April 1, 2024

**Re: Comments on Draft Environmental Impact Statement (DEIS) for Social and Ecological Resilience Across the Landscape 2.0 (SERAL 2)**  
(<https://www.fs.usda.gov/project/?project=63557>)

We submit the following comments on the DEIS for the SERAL 2 Project (“Project”). We support land management actions that reduce wildfire risk for people and nature while maintaining and protecting sensitive species and ecosystems. We are especially supportive of actions that restore the function of beneficial fire to landscapes, since it is through this natural disturbance process that resilience will be restored and biodiversity conserved. To this end, we very much appreciate the inclusion of prescribed fire in the proposed action (PA) over much of the project area and that this also includes some areas with prescribed fire as the first entry.

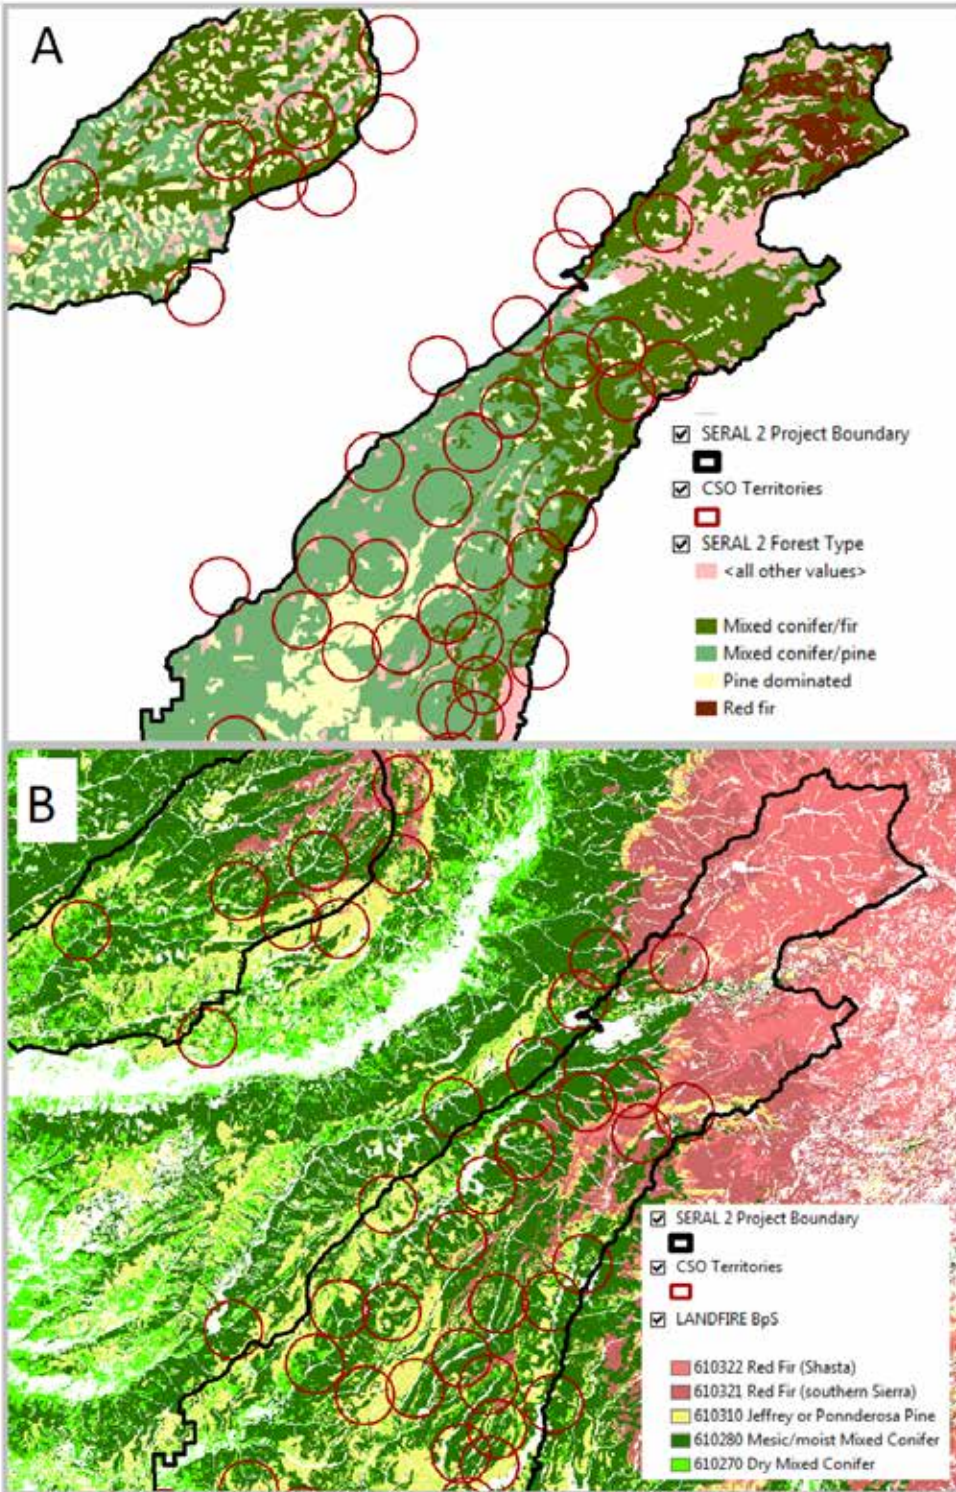
In contrast, the PA relies on an analysis that assigns “Moist Mixed Conifer” or “Dry Mixed Conifer” to the landscape, but does not specifically identify the criteria that were used to distinguish “moist” from “dry.” The project file includes a case study that compares the approach in SERAL 2 to the approach adopted in the revised forest plans for the Sierra and Sequoia National Forests (“Case Study”). The Case Study claims that the determination of Moist Mixed Conifer versus Dry Mixed Conifer was based on the methods in Huang et al. (2018) and Safford and Stevens (2017). This assertion is incorrect for a number of reasons. First, Huang et al. (2018) (cited in the Case Study), does not define the attributes that separate “Moist Mixed Conifer” or “Dry Mixed Conifer” as forest types. The reference cited describes the method (commonly called F3) to process remotely sensed data and apply it to landscapes. In fact, the only citation provide that defines “Moist Mixed Conifer” or “Dry Mixed Conifer” is Safford and Stevens (2017). The definitions of “Moist Mixed Conifer” or “Dry Mixed Conifer” are based on LANDFIRE BpS descriptions.

Second, the seral stage analysis used in Safford and Stevens (2017) also used LANDFIRE data to evaluate the abundance of seral stages. If the method used in Safford and Stevens (2017) is applied to SERAL 2, a significantly different distribution of desired seral stages would result with substantially greater amounts of Moist Mixed Conifer estimated on the landscape. We would also expect that the Safford and Stevens (2017) method would identify that the amount of CWHR 5M/5D is underrepresented on more of the landscape compared to the method used in SERAL 2.

Figure 1 illustrates the differences in distribution of “Moist Mixed Conifer” and “Dry Mixed Conifer” for the method used in Safford and Stevens (2017) versus SERAL 2. Two points of comparison are important to note. First, the overall amount of “moist mixed conifer” is greater using the method applied by Safford and Stevens. Second, territories themselves generally contain more “moist mixed conifer” type using the method applied by Safford and Stevens.

- Revise landscape analysis to utilize either the definitions and approach in Safford and Stevens (2017) or the revised forest plan for the Sierra National Forest (USDA Forest Service 2023b, p. 181, Appendix H). Revise Table B.01-4. Restoration Needs, and adjust desired conditions for territories accordingly.
